PRODUCT CHANGE NOTIFICATION

CLASSIFICATION OF CHANGE: VISUAL/APPEARANCE CHANGE 739W-X2/40

BEFORE:

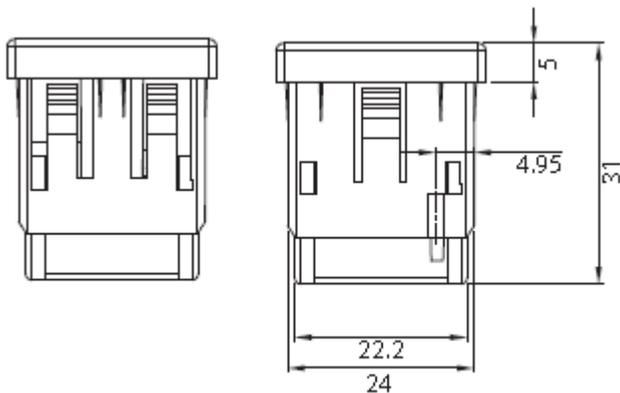
QUALTEK PART NUMBER 739W-X2/40 HAS BEEN MODIFIED TO ADD THE FOLLOWING MOLDING RELEASE RELIEFS NEAR ALL OF THE SNAP IN TABS AS SHOWN IN THE PICTURE BELOW:

THIS MODIFICATION WILL NOT CHANGE THE FUNCTIONALITY, SAFETY, OR USE OF THIS PRODUCT.
